Development Facilitation Team (DFT) – Review Comments

DRB Project No: PR-2020-003484 Date: 06/28/2023 Agenda Item: #9 Zone Atlas Page: E-10

THE GROUP | RON HENSLEY agent for **NAFEESA PASHTOON** requests the aforementioned action(s) for all or a portion of: **LOTS 2 & 3 BLOCK 12 UNIT 3, VOLCANO CLIFFS SUBD** zoned **R1-D** located on **MOJAVE ST NW between UNSER BLVD and TESUQUE DR** containing approximately **4.25** acre(s). **(E-10)** [Deferred from 4/12/23, 4/26/23b, 5/10/23b, 5/24/23b, 6/14/23, 6/28/23]

Development Hearing Officer
Planning - Case Comments

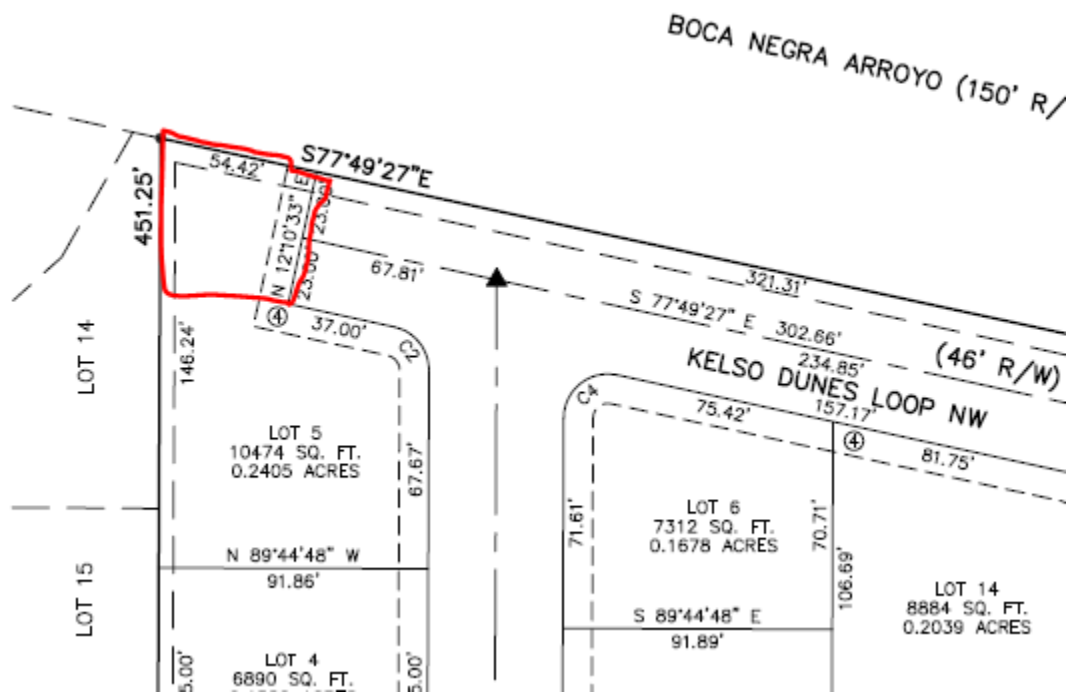
- **Updated 10.11.23:** The meeting with the NPS and City Open Space indicated that they feel strongly that pre and post construction inspections need to be held to ensure that the environmental integrity of the Open Space is not compromised during construction. Following a meeting with National Park Service, City Open Space and Planning, a

Sensitive Lands Preservation sheet needs to be added to the Plat set before the Final Plat is approve. The Sensitive Lands Preservation sheet should indicated:

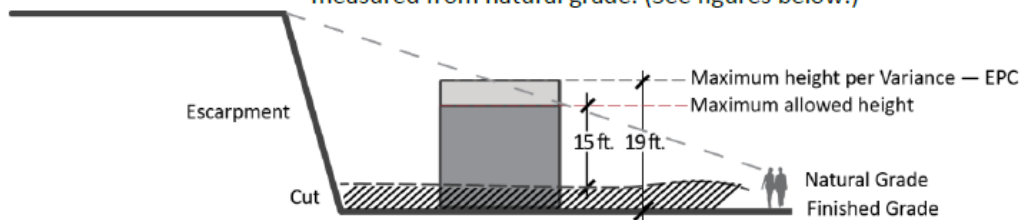
IDO 3-6(E) The parcels are in the VPO-2 Height Restricted Sub Area. Identify the allowable structure height vis a vis grading plan. 'Building and/or structure height shall

not exceed 15 feet, as measured from natural grade.'

- ✓ The applicant has shown height measurements from finished grade and natural grade and established maximum building heights that do not exceed 15 feet.
